Plan Commission Meeting Agenda

September 1, 2016 7:00 P.M.

PC 2016-024
PLAN COMMISSION ADVISORY REPORT

**Re: Ogden Hill East Multi-Tenant Building – Final Engineering Plans
4th Submittal
Montgomery, Illinois**

| PROJECT NO. 130266A DATE : 06/24/2015 DRAWING NO. GM1 SHEET : 7 OF 19 | |

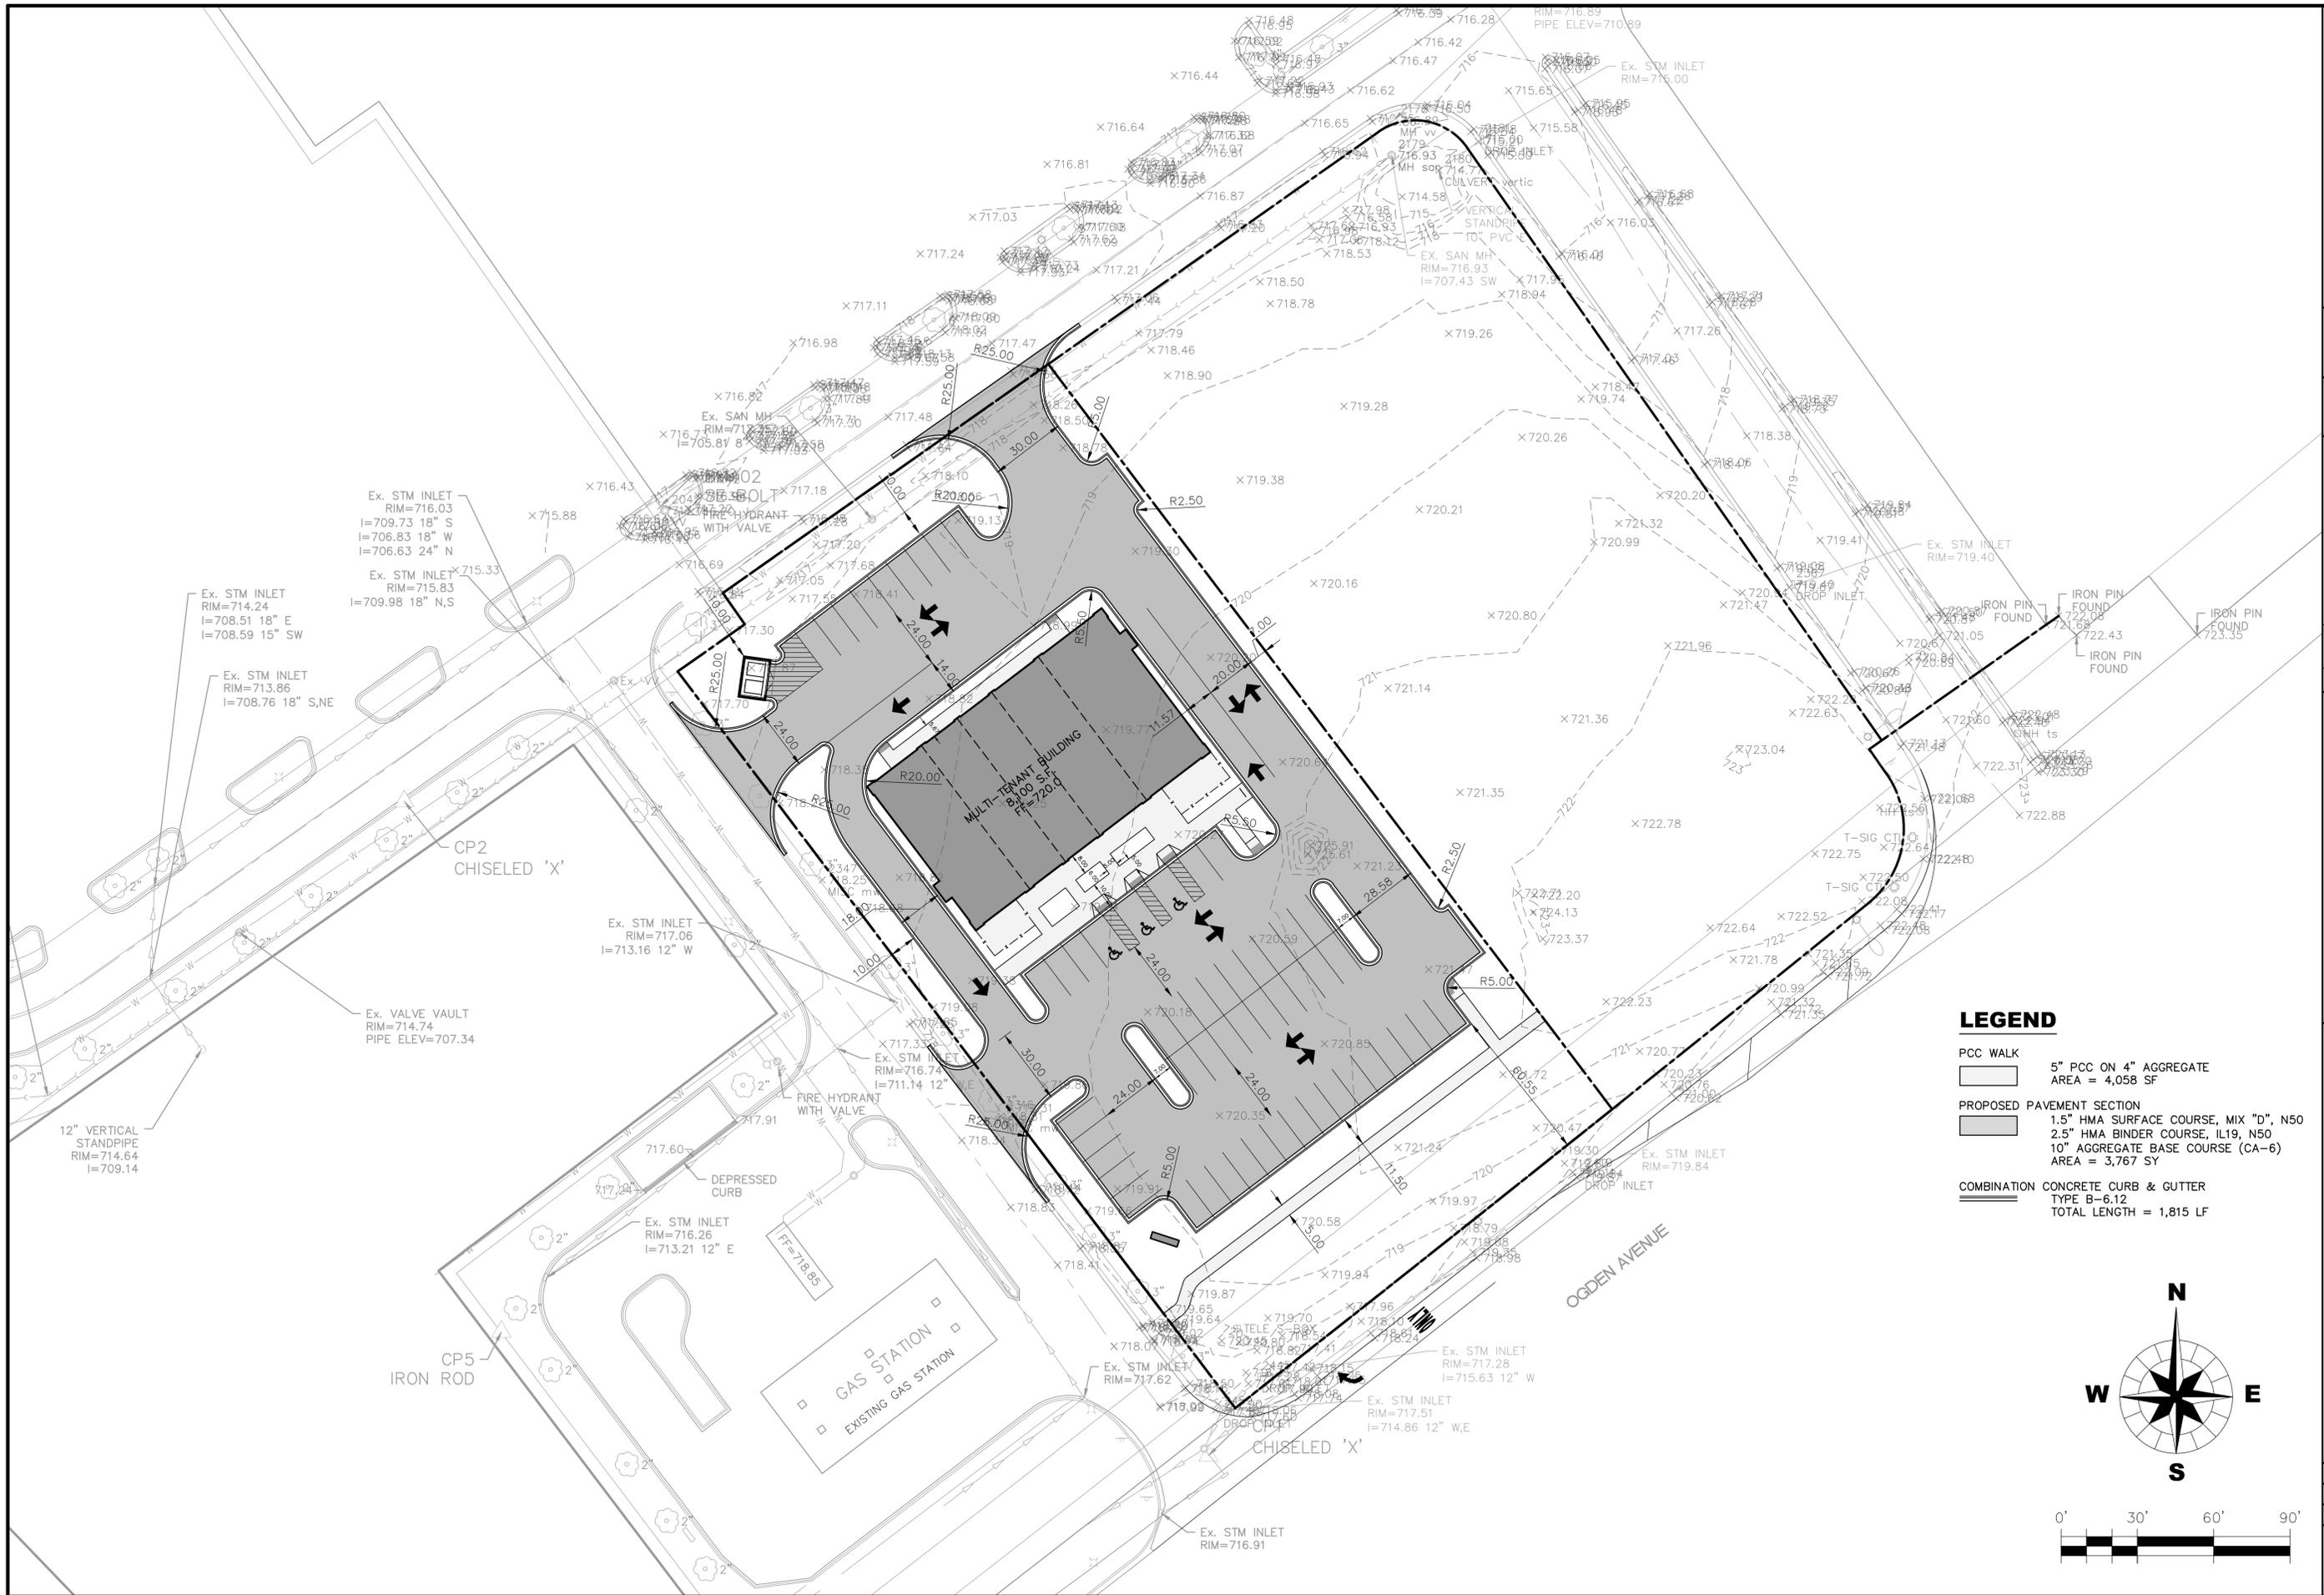
6. The 20-foot drive aisle on the east side of the building next to the new drive through lane needs to be changed to a one-way drive since it does not meet the required 24-foot width for a two-way drive aisle. In addition, the appropriate striping and signage should be added to the plan.

The above items should be addressed and the engineering plans re-submitted for approval. If you have any questions or need additional information, please contact our office.
